PROJECT: King Street Church (Project No. 1526)
Chambersburg, Pennsylvania

DATE: March 30, 2016

ADDENDUM #3
(Clarifications and Revisions)

3.02 Sheet A601 Room Finish and Door Schedules (Revision #2 dated 03/29/16)

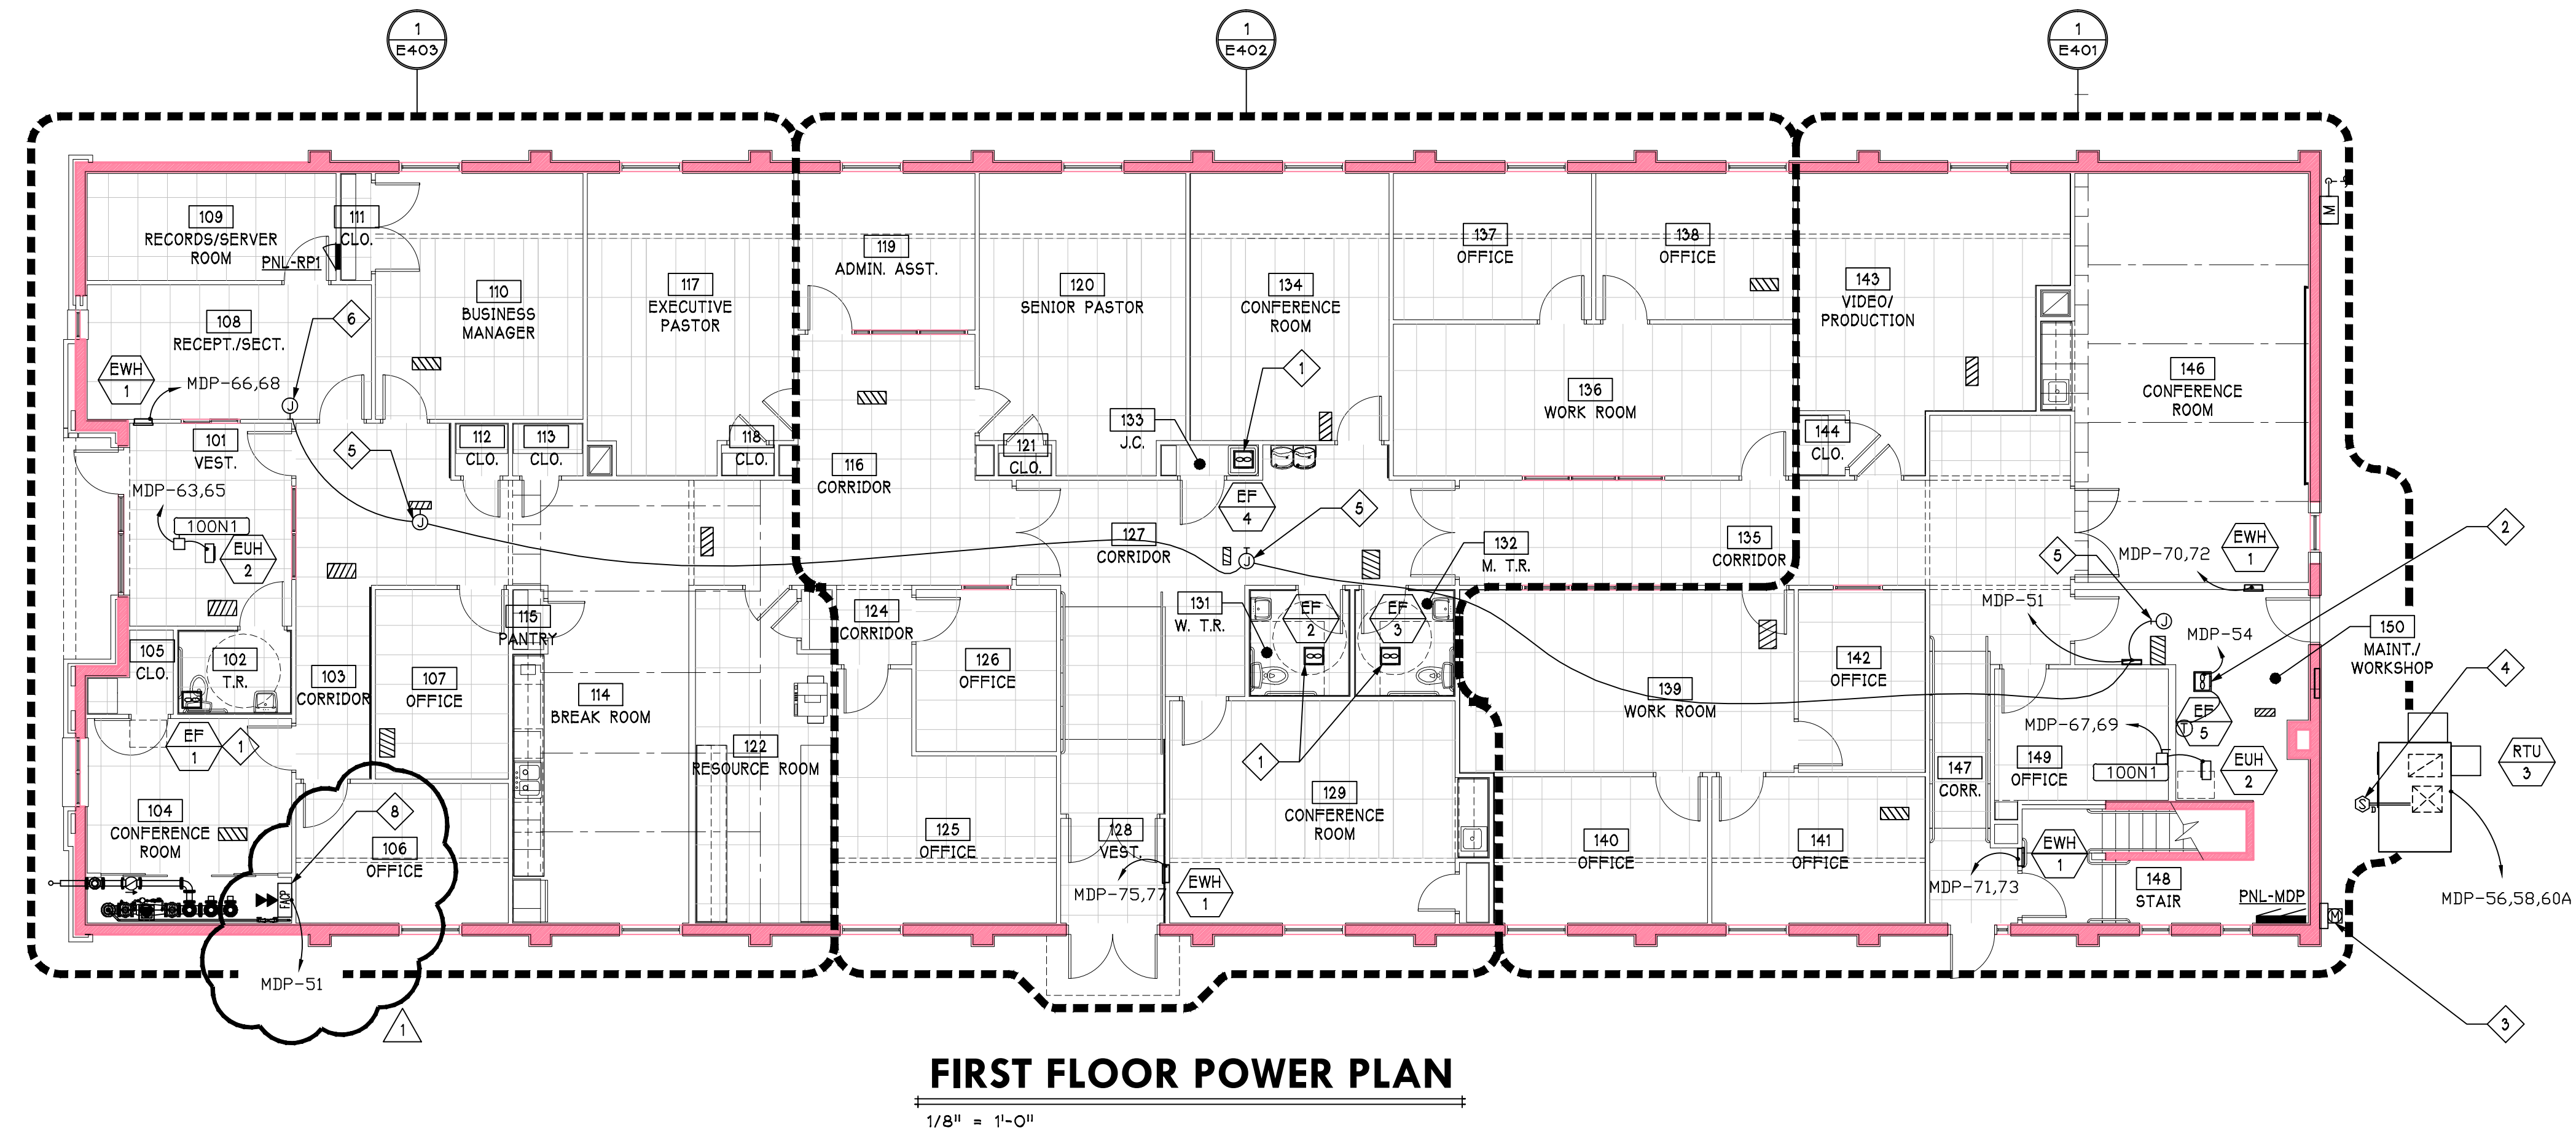
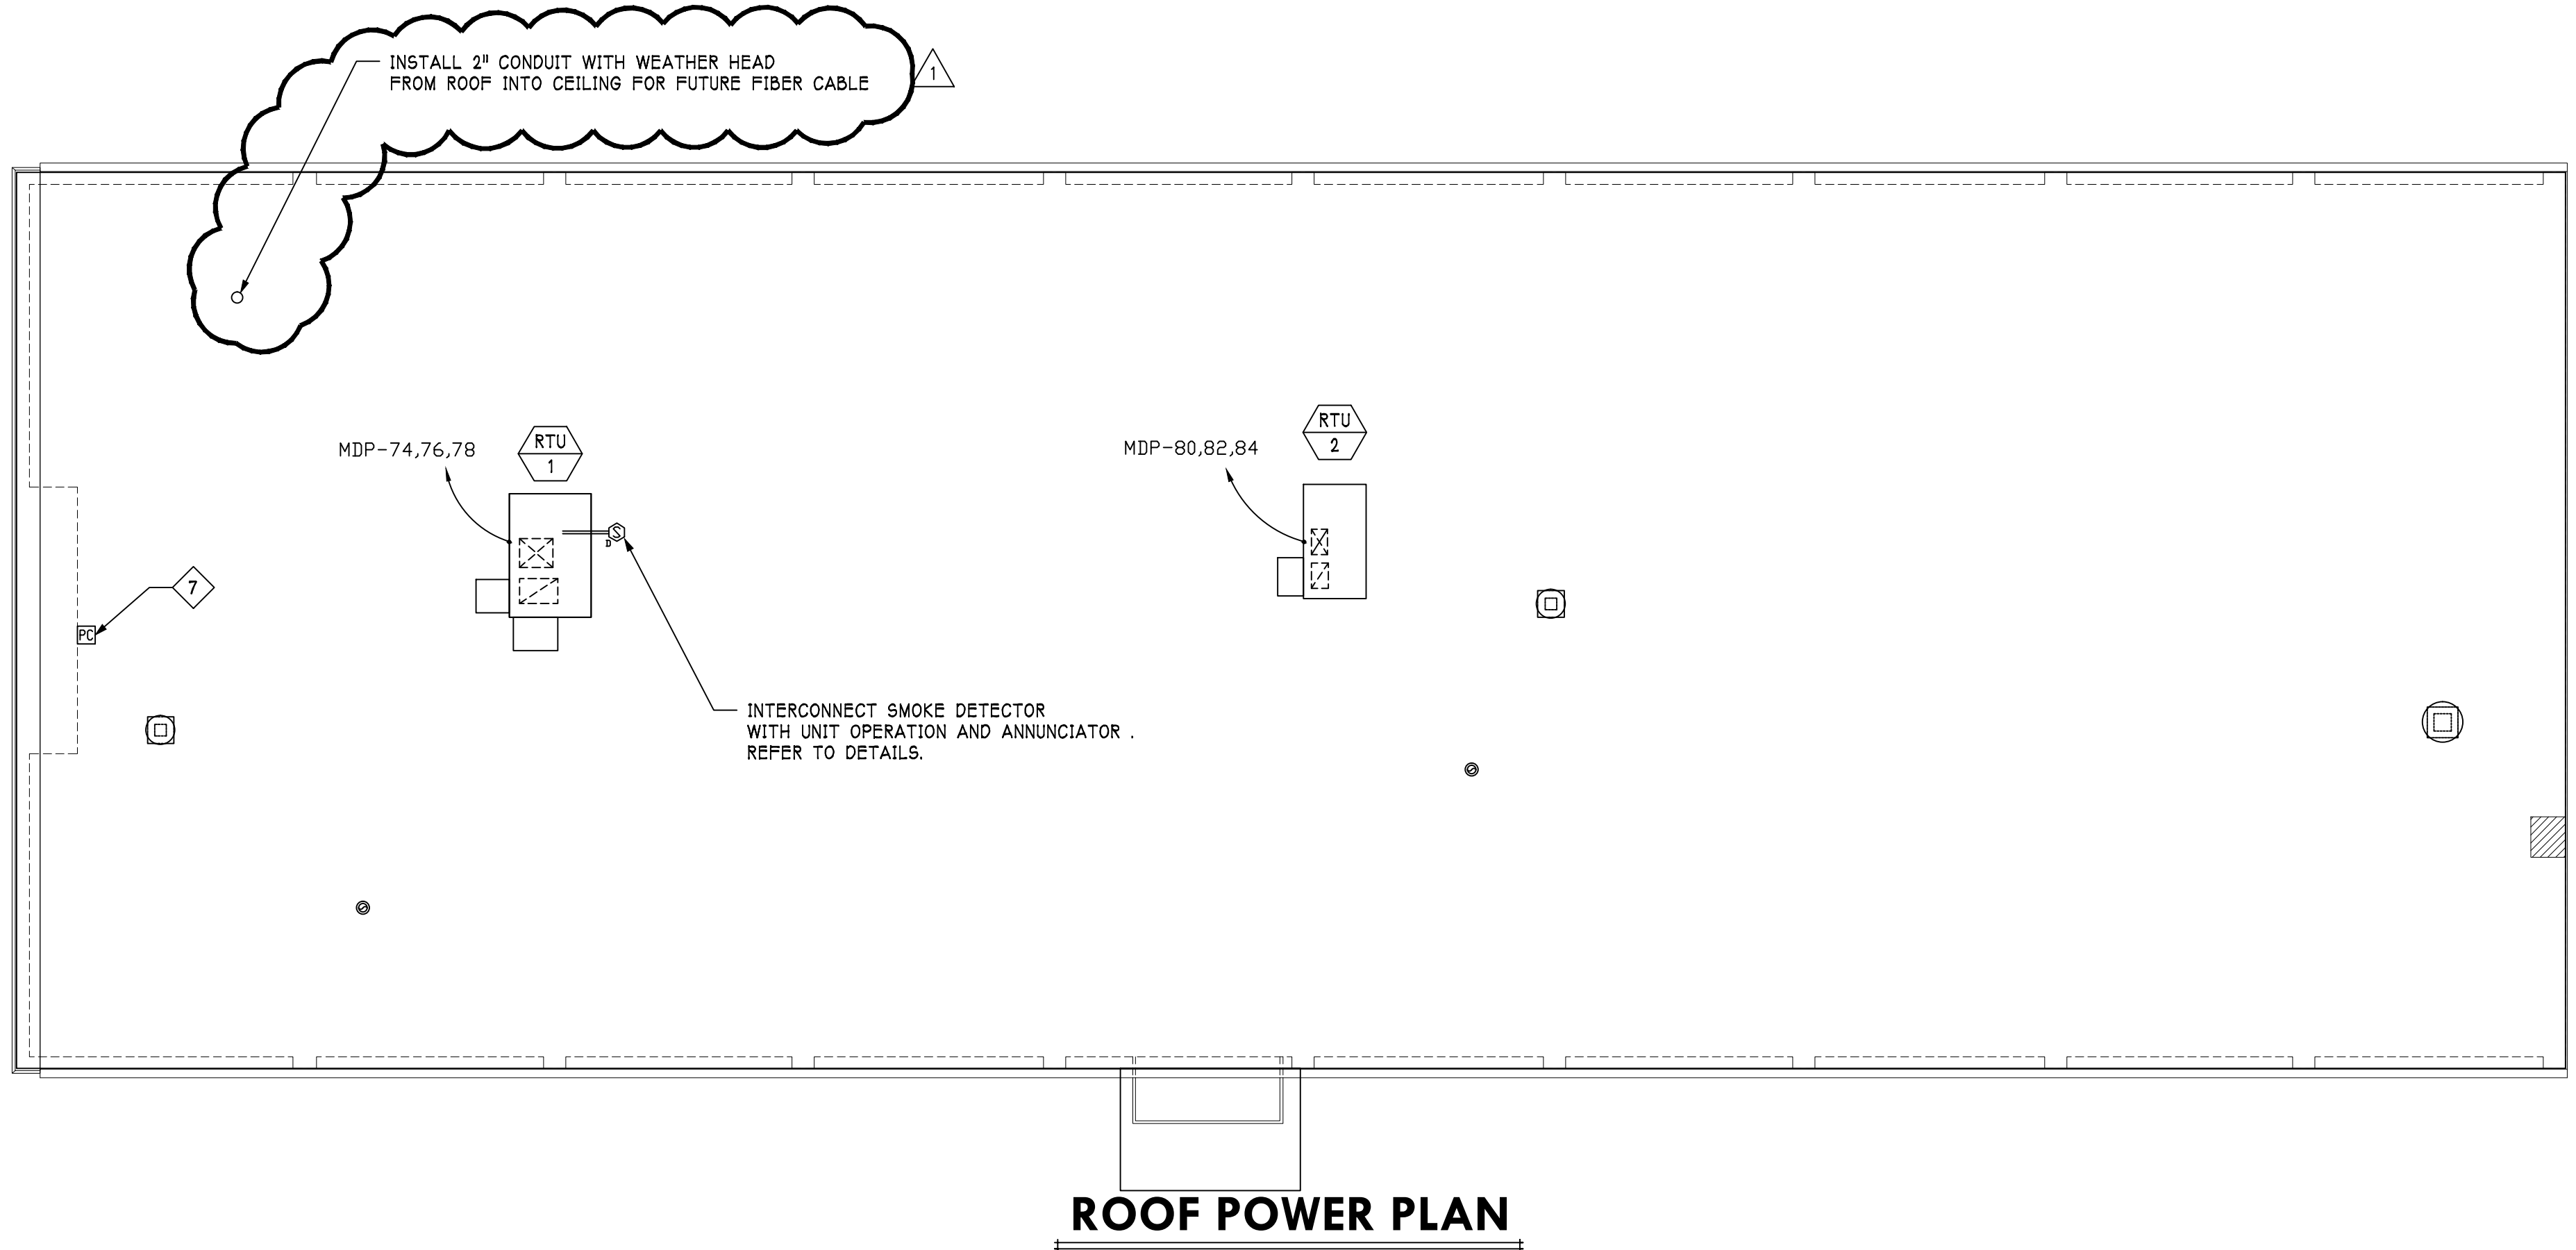
A. REVISE

Ceiling Material and Remarks

3.04 Sheet E201 Power Plans (Revision #1 dated 03/29/16)

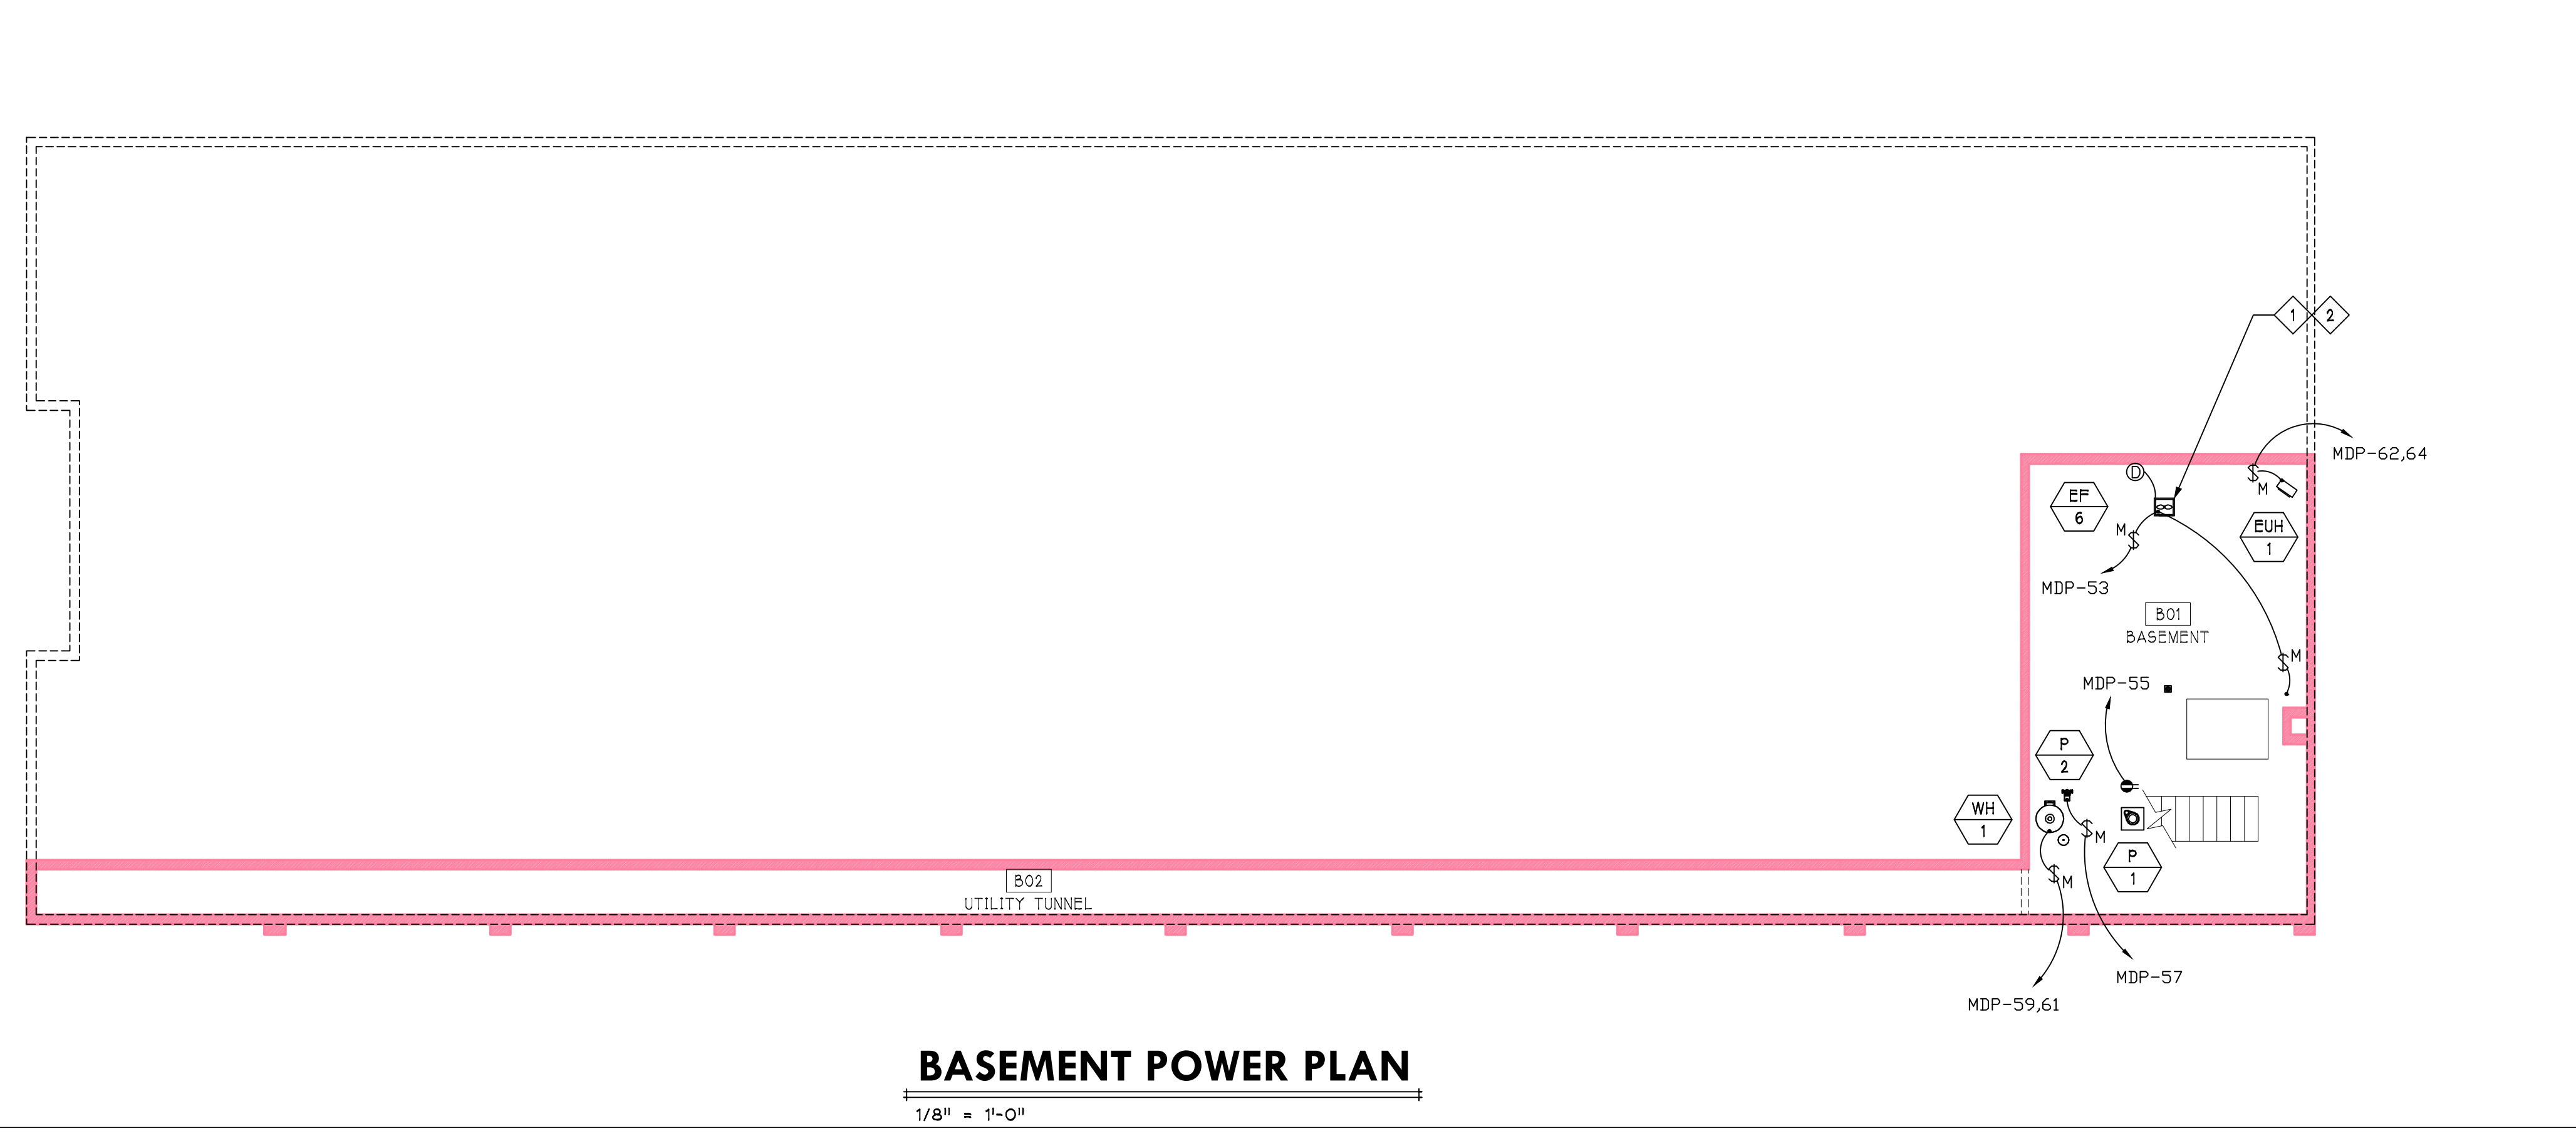
A. ADD Details

B. REVISE Floor Plan Keyed Notes

- CONNECT TO LIGHTING CIRCUIT FOR SPACE. REFER TO LIGHTING PLANS.
- LINE VOLTAGE THERMOSTAT PROVIDED BY OTHERS AND INSTALLED BY ELECTRICAL TRADE. COORDINATE WITH MECHANICAL TRADES.
- INSTALL NEW METER BASE FOR NEW ELECTRICAL SERVICE. COORDINATE WITH LOCAL UTILITIES AND MECHANICAL TRADES.
- INTERCONNECT SMOKE DETECTOR WITH MECHANICAL EQUIPMENT OPERATIONS AND CENTRAL MONITORING SYSTEM. REFER TO DETAILS.
- INSTALL CONTROL TRANSFORMER PROVIDED BY MECHANICAL TRADES AND PREPARE LOCATION FOR LOW VOLTAGE CONNECTIONS BY MECHANICAL TRADES.
- LOCATION OF STAND ALONE DUCT SMOKE DETECTOR SYSTEM. REFER TO DETAILS.
- EXTERIOR SITE LIGHTING PHOTOCELL CONTROL. INSTALL PER MANUFACTURERS INSTRUCTIONS.
- INSTALL NOTIFIER 4TUDAC FIRE ALARM COMMUNICATOR OR APPROVED EQUAL INCLUDE (2) DEDICATED PHONE LINES AND CONNECT TO FIRE PROTECTION FLOW AND TAMPER SWITCHES.
